SERVICE INFORMATION BULLETIN #6

GRAFLEX, Inc.
Rochester 8, New York

20 August 1956

SUBJECT: 1. IDLER FILM GUIDES - ASSEMBLY OF:
2. IDLER REPLACEMENT.

Figure 2. HOLDER COMPLETE - ROLL FILM

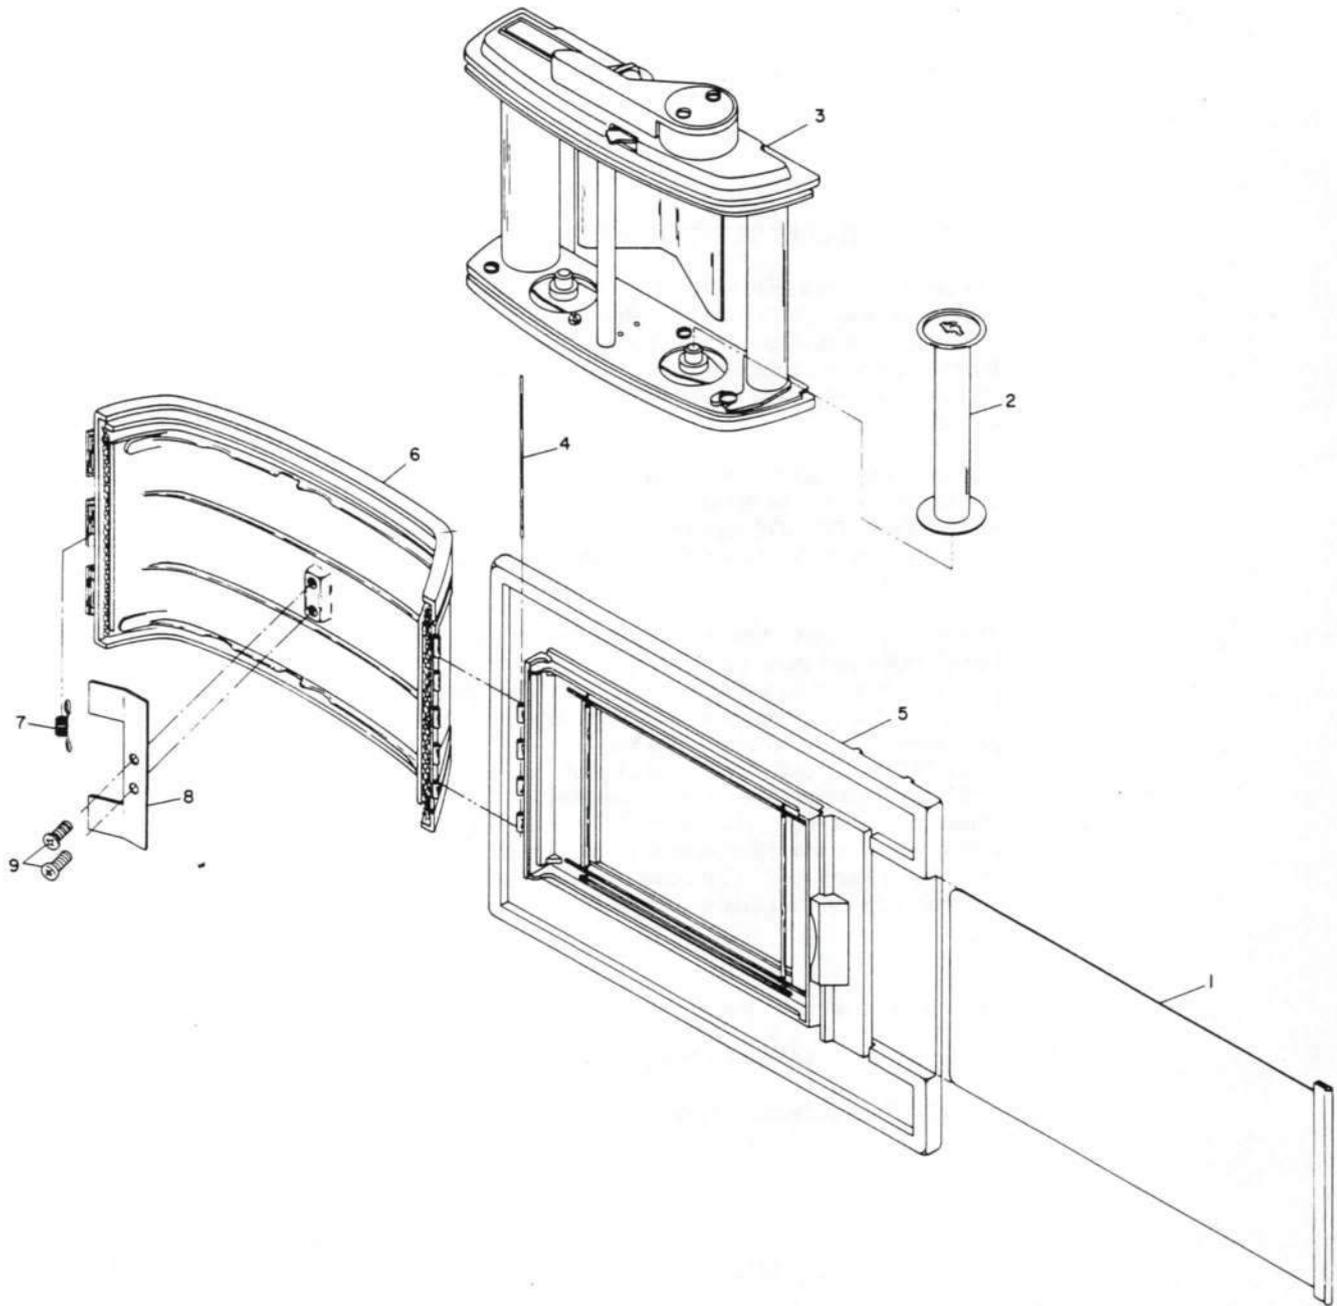
REASON FOR CHANGE: 1. To keep film from running off edge of idler.
2. Improve idler bearing.

DESCRIPTION OF CHANGE: 1. Minor - replace screw and add film guides, 2 required.
2. Disassemble complete; drill bearing holes larger.

1.1. Reports of difficulty in winding certain films through the Graflex Roll Holders have been the subject of considerable investigation. We believe that the cause can be attributed to the fact that under certain conditions the film strip itself buckles slightly under the paper backing between the idler and the takeup spool, and tends to drift from one side to the other, causing it to pile up against the flange of the spool and in some instances to override this flange. To prevent this, a film guide is assembled to the carriage at each end of the take-up spool idler.

1.2. Remove the 1/4 inch long, round head, self tapping screw (5, figure 2) from the carriage at each end of the take-up spool idler and discard.

2.1. Roller (32, figure 2) having 0.621 inch outside diameter and 0.125 inch diameter bearing can be used if the idler roller holes of carriage(31) are enlarged to 0.128, plus 0.001, minus 0.0005 inch diameter. Use drill press and 0.128 inch diam. (#30) drill.

Figure and Index No.	Part Number	1 2 3 4	Qty.	List Price
2-5	33921-P23	. . Screw-Self tapping, #4, 0.375 in. lg, round head required for film guide 33788, (Replaces 30921-P21)	2	.02
2-9	33921-P20	. . Screw-Self tapping, #4, 0.312 in. lg, round head (Replaces 30921-P21)	4	.02
Add 2-30A	33788	. . Guide-Film (Requires screw 33921-P23) . .	2	.05
2-32	33947-P1	. . Roller, 0.621 in. dia, with 0.125 in. diam. bearing (Replaces 31803-P1 and 33906-P1)	2	.55

1.3. Position the film guide (#33788) with curved end around the shoulder end of the take-up spool idler and secure with 3/8 inch long, round head, self tapping screw (#33921-P23).

NOTE: Be sure that the guide does not contact the idler and prevent it from turning freely.
